**LEBANON PLANNING BOARD
DECEMBER 9, 2024 - 6:30 PM
COUNCIL CHAMBERS, CITY HALL OR
REMOTE VIA VIRTUAL PLATFORM
LEBANONNH.GOV/LIVE**

Staff Memorandum – PB2024-22-SPRCUP – *con't from 11/12/24*

Site Plan Review and CUP for a proposed 474-unit multi-family PURD, and a CUP to allow an increase in the maximum permitted building height from 45 ft. to 55 ft.

- ▶ Plan set titled “The Brickyard Residential Development,” dated May 10, 2024, latest issue December 4, 2024, prepared by VHB, EV Project: 52933.00 (53 sheets plus cover sheet)

Drawing Title
**Wildland-Urban
Interface Plan**

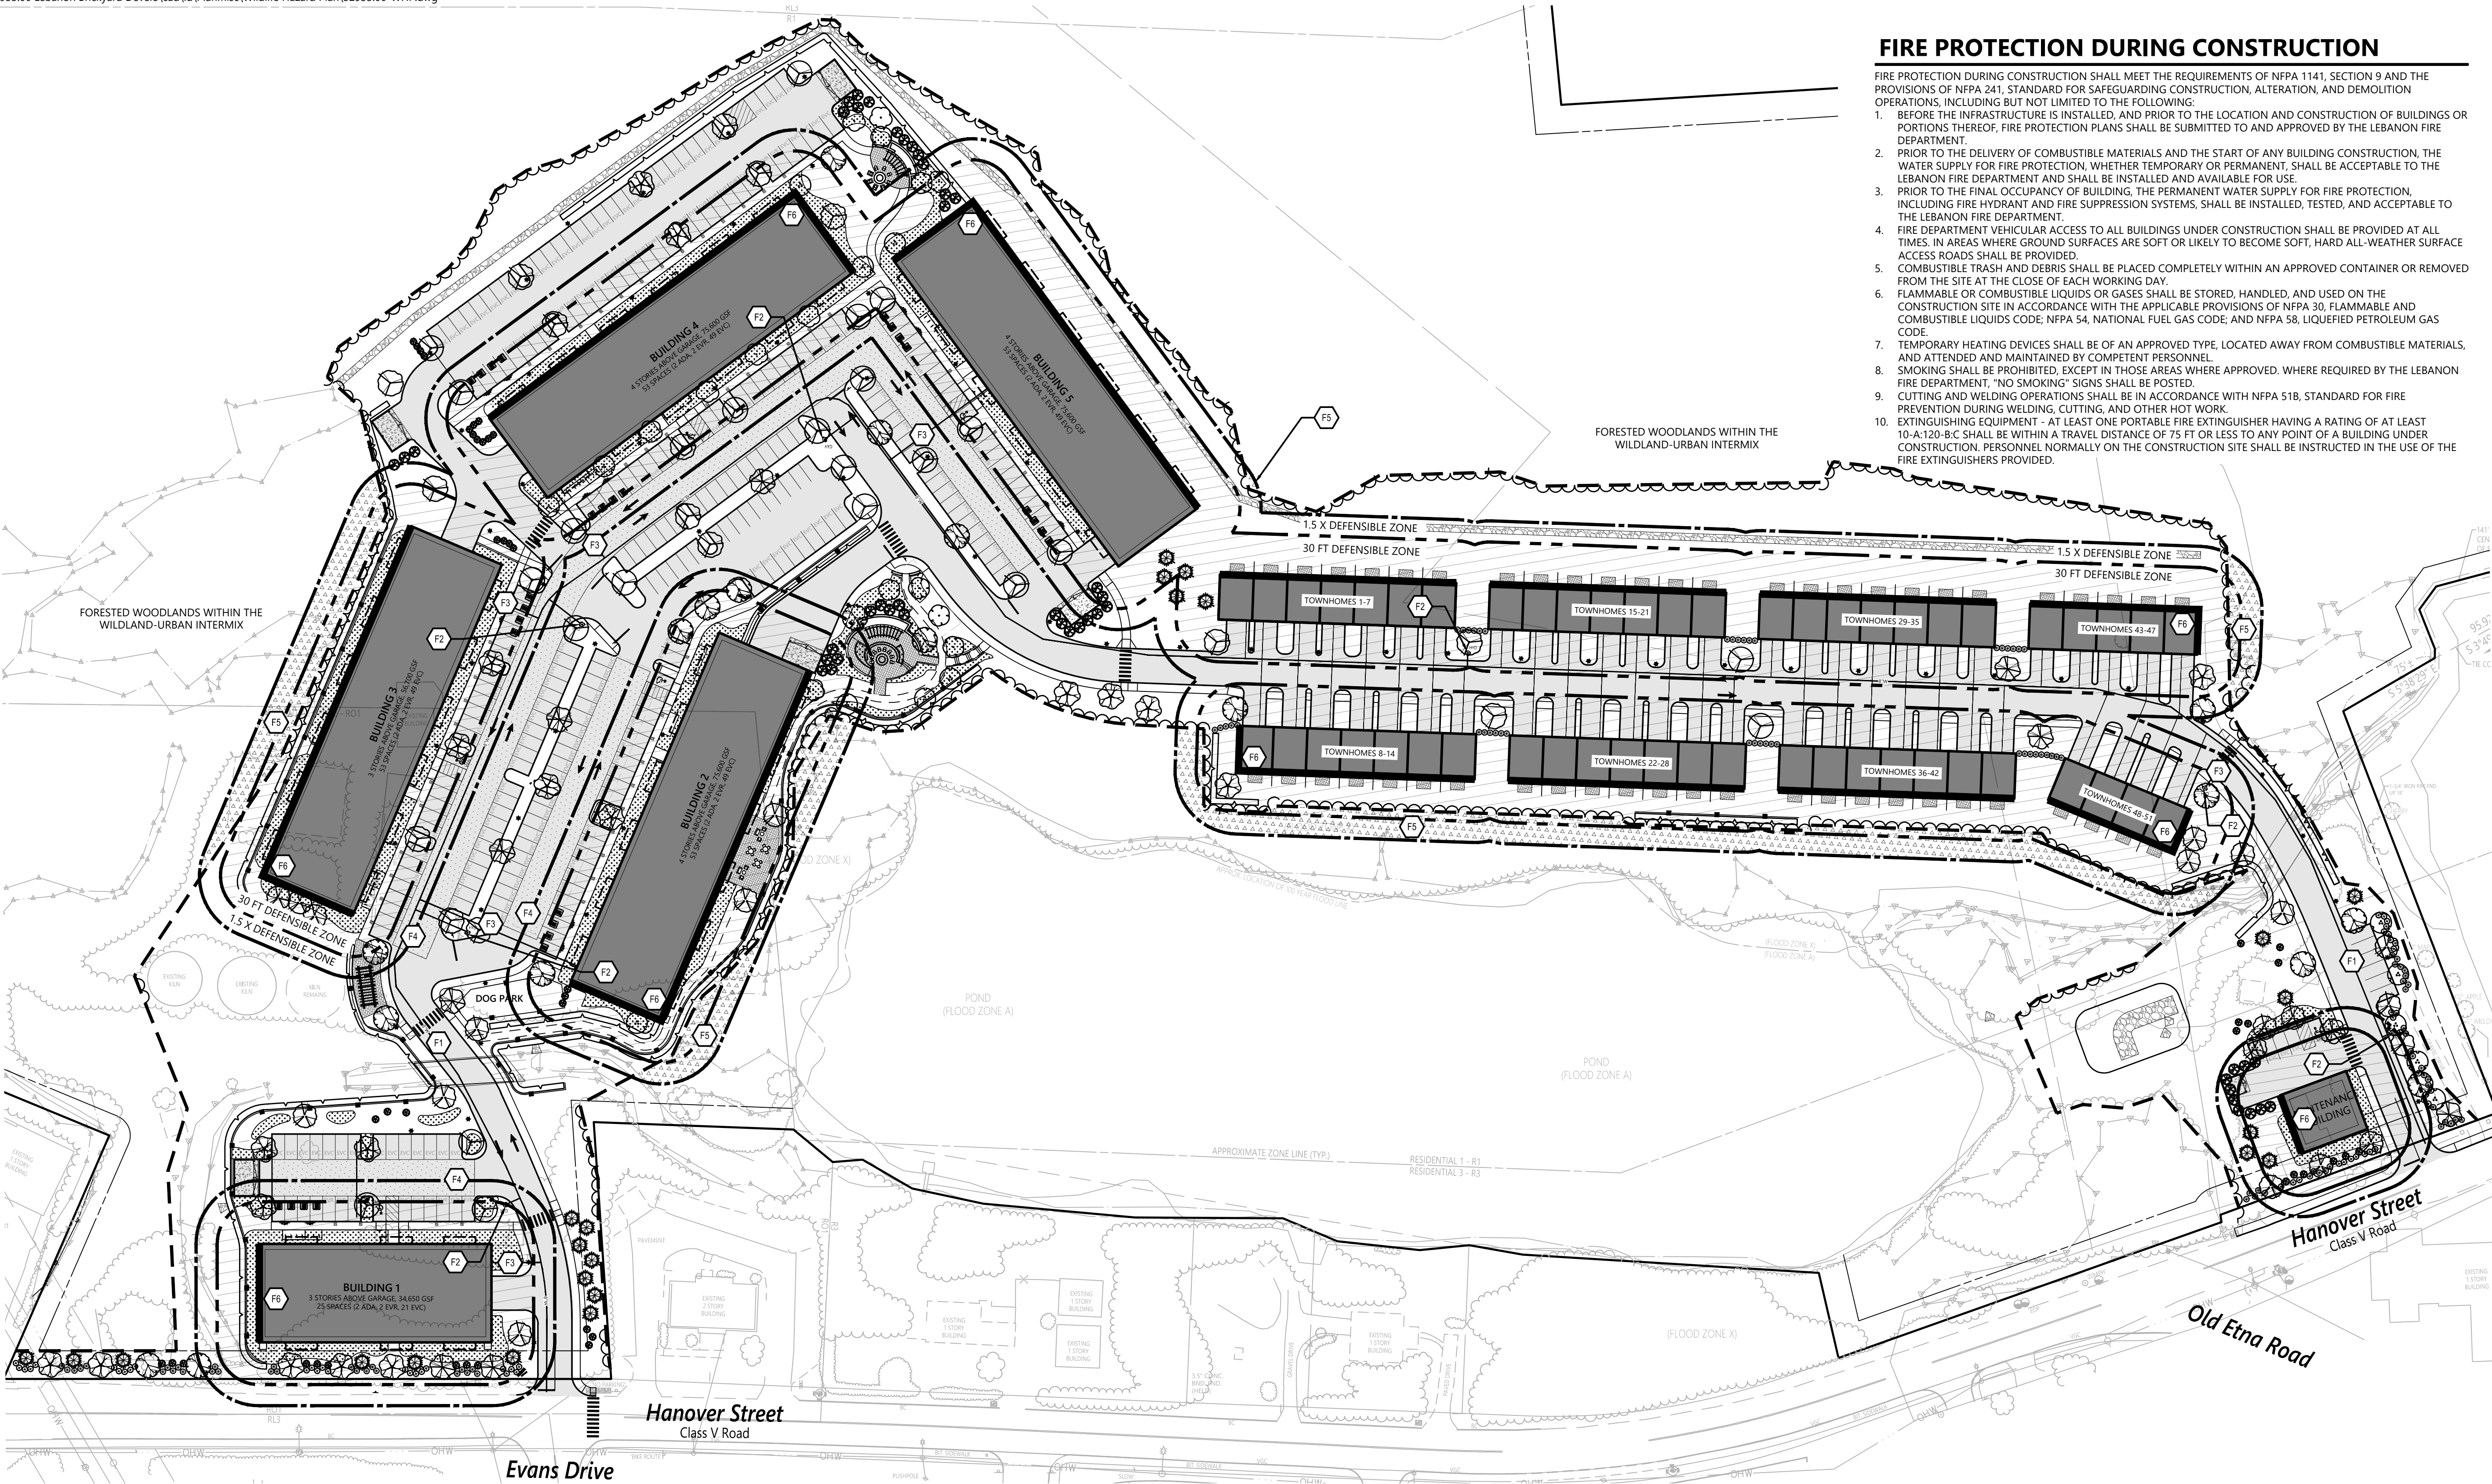
32. Sheet 47

Response: A Wildland Fire Hazard Assessment Plan has been added to the Site Plans (sheet WU-1).

BUILDING 2 | Parking Level Plan

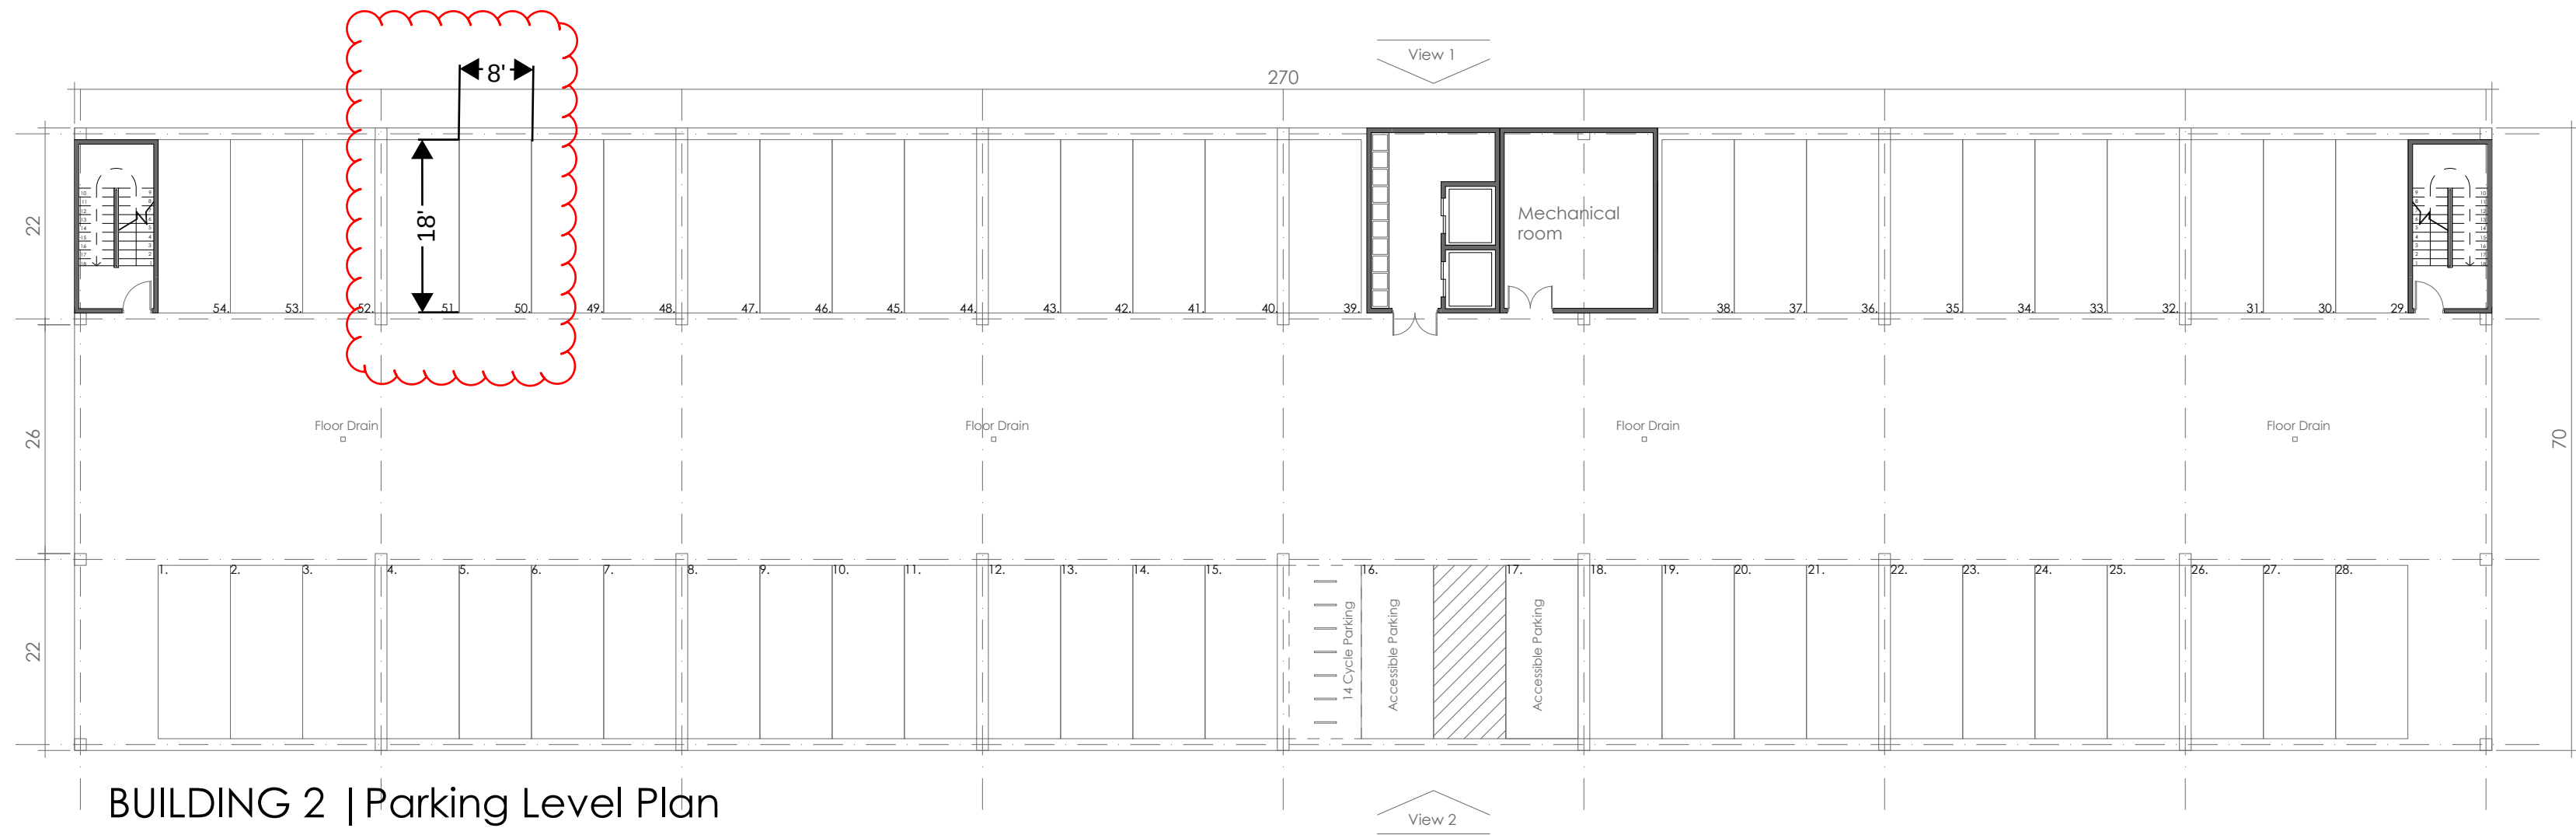
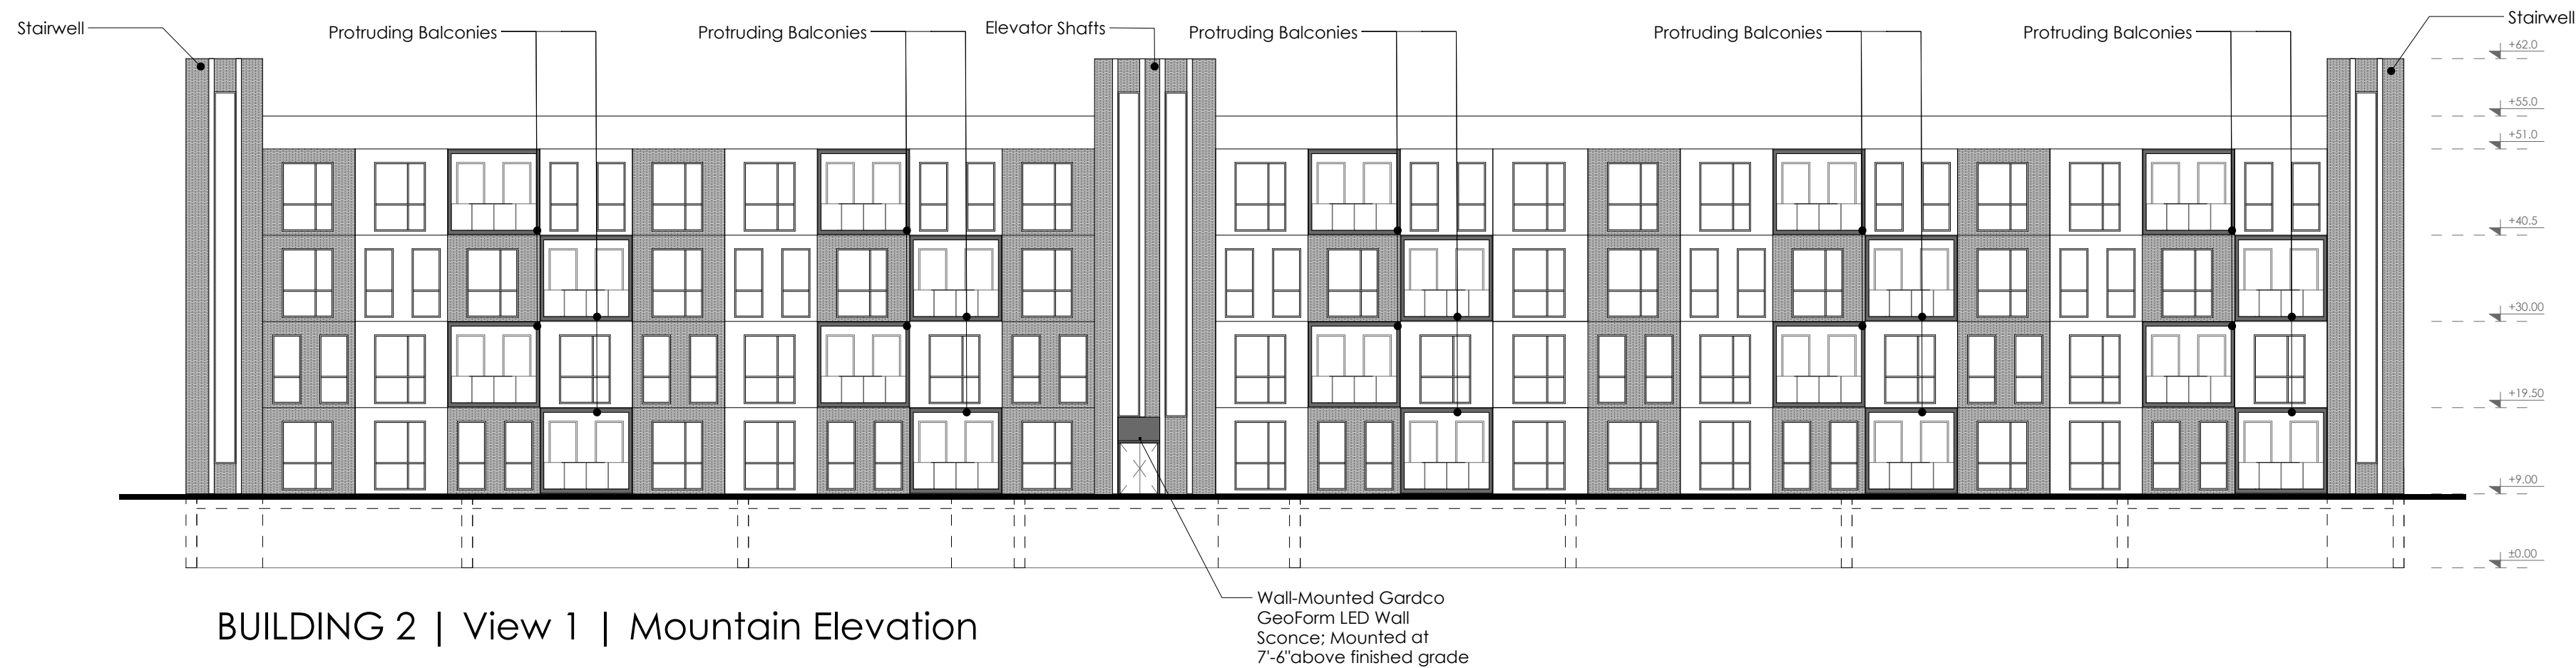
-
- 11. Sheet 36 – why does the development need to be designed to accommodate a semi-trailer?
- 12. Building 2 is located partially in the R-O District and therefore is restricted to a 45 ft. maximum height, whereas the plan set throughout indicates that Building 2 will be 55 ft. Please update
